# Product Change Notification (PCN)

PCN Number	510027	Date Issued	April 22, 2021
Reason for Change	Change to Product		
Change Type Description	This letter is to inform you that changes are being made to the part(s) identified in this Notice. The change may affect the fit, form, function or appearance of the parts, or it may result in a change to the specification. The pictures below show an example of the possible differences.		
Assessment of Change	No change to parts/components FFF		
Internal Molex Qualification Date	April 22, 2021		
Sample Availability Date (Changed Part)	April 22, 2021		
Planned Implementation Date	October 20, 2021		
Method of Identifying Change	No special marking on the product or packaging

Change Point : PicoBlade 1.25mm W/W PLUG Housing (PN; 51047\*\*00)

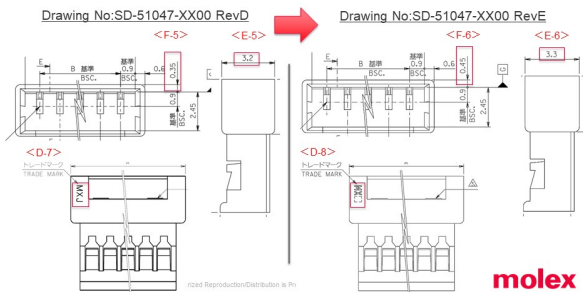
- Purpose of the change
  - SD-51047-XX00 had typed on the dimensions shown left picture, so we will correct these dimensions on the drawing to match to the manufacturing drawing. There is no affect on the actual product.
    - <F-5> 0.35 change to 0.45
    - <E-5> 3.2 change to 3.3
  - The expression of the trademark on SD will be changed, due to the last alphabet at trademark will depends on manufacturing location.
    - <D-7> MXJ change to MX□
  - SD will be revised up : SD-51047-XX00 RevD ⇒ SD-51047-XX00 RevE
- Product Impact
  - **No impact to Fit, Form or Function.** There is no change the product itself.
- Part Number Impact
  - Refer to the attached impacted parts list.
